ADDENDUM NUMBER: THREE

ISSUED BY: SEPW Architecture Inc.
109 – 3725 Pasqua St., Regina, SK. S4S 6W8

**PROJECT: INTERIOR FIT-UP PHASE 2
REGINA, SASKATCHEWAN**

This Addendum forms part of the Contract Documents and amends the original Drawings and Specifications dated 2017-02-03, previous Addenda if applicable and as noted below. This Addendum consists of 7 pages.

SIDEWALK, CURB & GUTTER

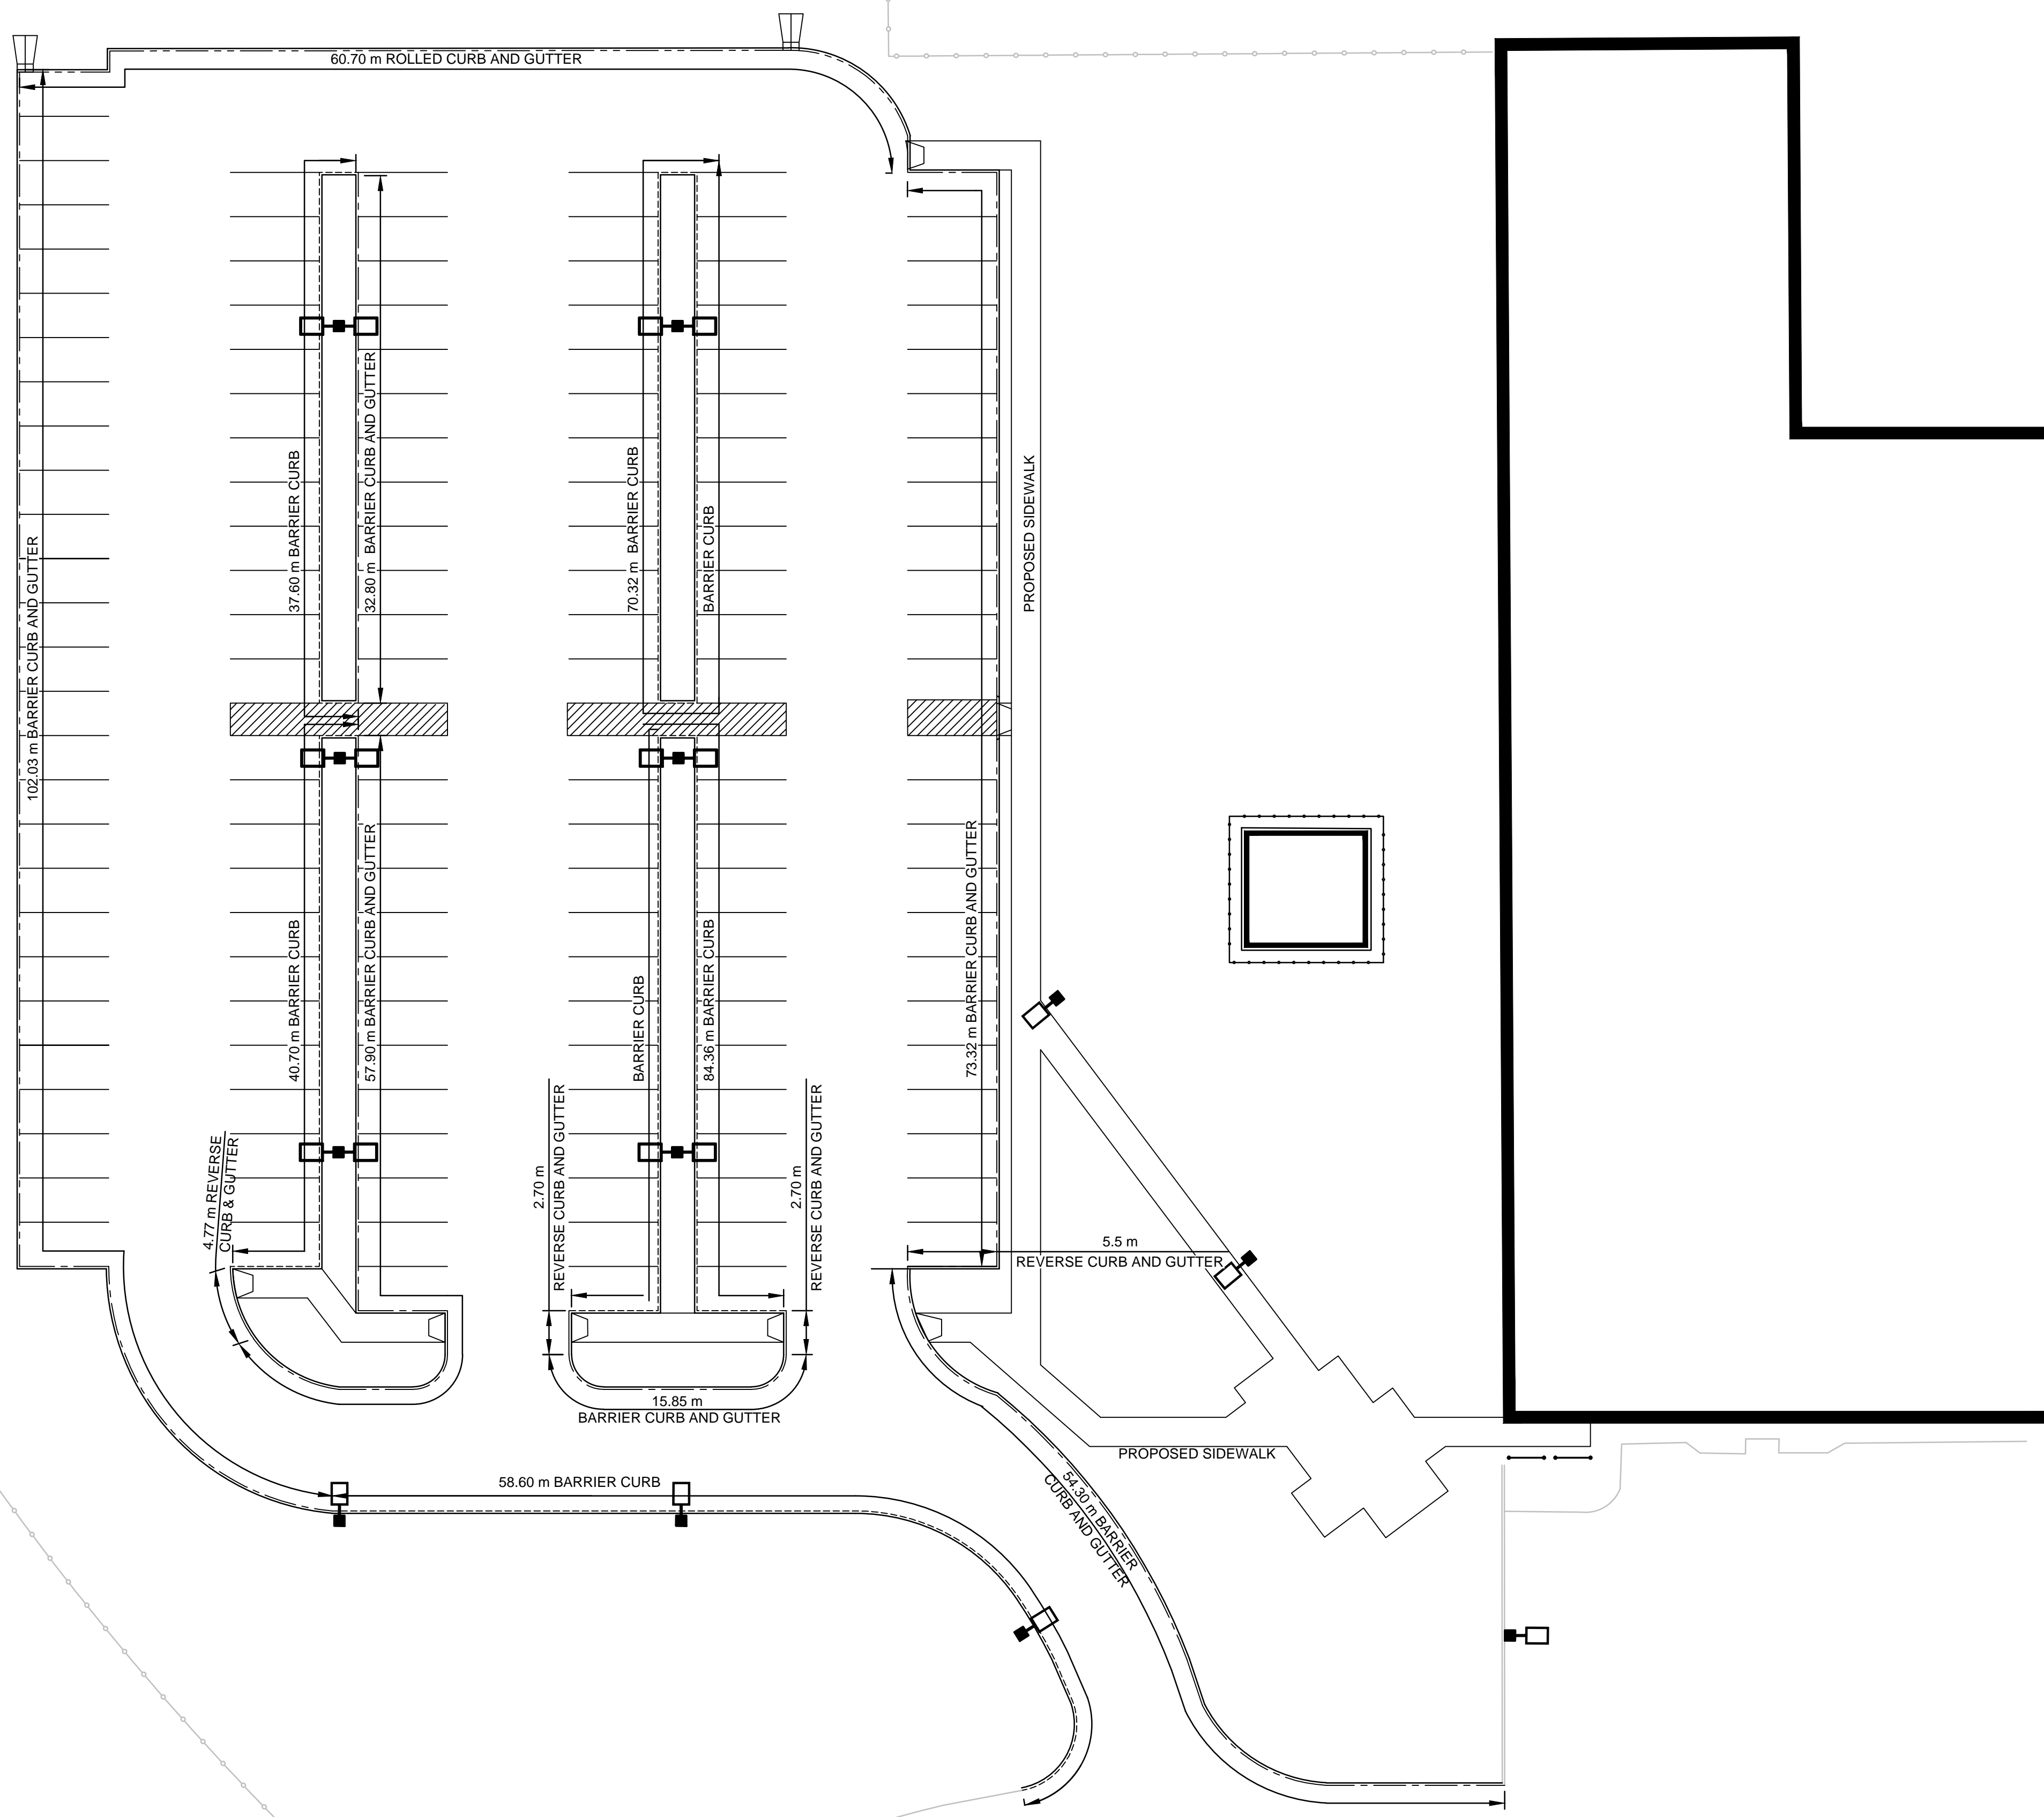
Q43: Drawing C1.2: Barrier Curb & Gutter Lengths

- a. Section along the west side of the parking lot doesn't show a length like the rest.
- b. Section along the east side of the parking lot states 121.9m, however, measures out at 73.64m; please confirm. The rest worked out.

A43: *Refer to Drawing C1.2 (Revised 2017-06-07) attached to this Addendum.*
